Response to Submissions (RtS) Comments 12 and 15 November 2021

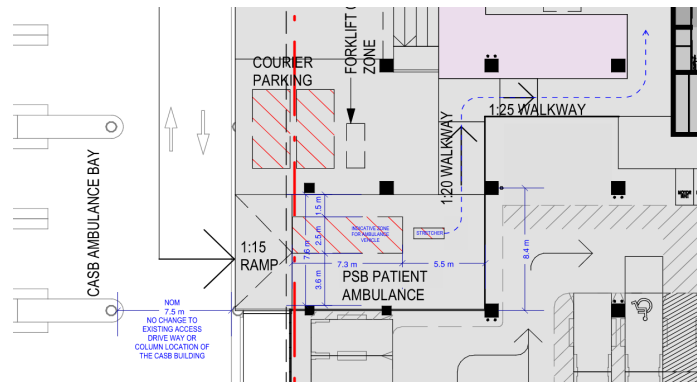
7	<p>Parking space layout and dimensions</p> <p>It is recommended that the plans be revised to provide shared areas for disabled parking spaces that is compliant with AS2890.6-2009. Note that bollards are to be installed in accordance with Figures 2.2 and 2.3 of AS2890.6-2009. Furthermore, it is also recommended that plans be revised to include directional pavement arrows/signs to indicate the one-way traffic flow within the car park.</p>	<p>As depicted in the image below, shared areas with complying dimensions have been provided for car parking spaces for people with disability. Additionally, the traffic circulation within the car park has been indicated to be one-way in the clockwise direction as shown on drawing CHW-AR-DG-PSB-SSD011 - PROPOSED PLAN - LEVEL 02 and CHW-AR-DG-PSB-SSD026 - PROPOSED PLAN - LEVEL 02 CARPARKING .</p> <p>Bollards in the shared area and pavement arrows can be readily included in the car park layout to comply with the Australian Standards (AS2890.1 and AS2890.6 for off-street car park and off-street parking for people with disability respectively) as part of the Conditions of Consent.</p>  <p>Figure 1 PSB Level 02 off-street car parking</p>
